# Access Compliance Report

## Public Rights-of-Way

Intersection ID: 44006	Main Street: DEMAINE_DR	Cross Street: ELROSE_PL	Location:	N
ADA ID: C2728329FE7D	Ramp Type: PerpDiag	Initial Pass/Fail: Fail	Overall Compliance: No	Severity Score: 10

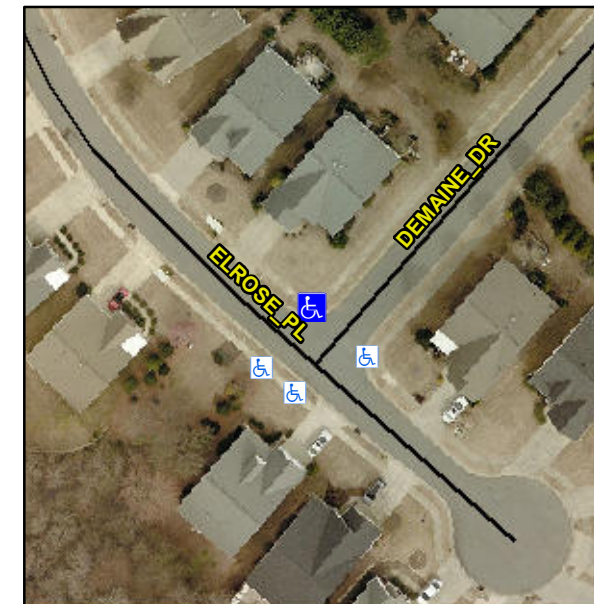
**Not Found, R304.5.1, R304.5.3**

Compliance	Description	Data	Compliance	Description	Data
N/A	Ramp Length (in)	48.0	Yes	Ramp Slope (%)	5.5
No	Ramp Width (in)	44.0	No	Ramp XSlope (%)	4.3
N/A	Flare Type LT	N/A	N/A	Flare Type RT	N/A
N/A	Flare Slope LT (%)	N/A	N/A	Flare Slope RT (%)	N/A
N/A	Flare Traversable LT?	N/A	N/A	Flare Traversable RT?	N/A
N/A	Landing Length (in)	N/A	N/A	DWS Provided?	N/A
N/A	Landing Width (in)	N/A	N/A	DWS Contrast?	N/A
N/A	Landing Slope (%)	N/A	N/A	DWS Length (in)	N/A
N/A	Landing X Slope (%)	N/A	N/A	DWS Full Width?	N/A
N/A	Landing Curb? (Y/N)	N/A	N/A	DWS Offset (in)	N/A
N/A	Shared Landing?	N/A			
N/A	Gutter Ponding?	N/A	N/A	Gutter Slope (%)	N/A
N/A	Gutter Lip Ht (in)	N/A	N/A	Gutter X Slope (%)	N/A
N/A	Painted X Walk1?	No	N/A	Painted X Walk2?	No
	X Walk 1 Direction	To SW		X Walk 2 Direction	To SE
N/A	X Walk 1 Width (in)	N/A	N/A	X Walk 2 Width (in)	N/A
	X Walk 1 Slope (%)	4.0		X Walk 2 Slope (%)	1.4
	X Walk 1 X Slope (%)	2.8		X Walk 2 X Slope (%)	4.2

**Remove & Replace Curb Ramp With Two New Directional Ramps or Equivalent.**
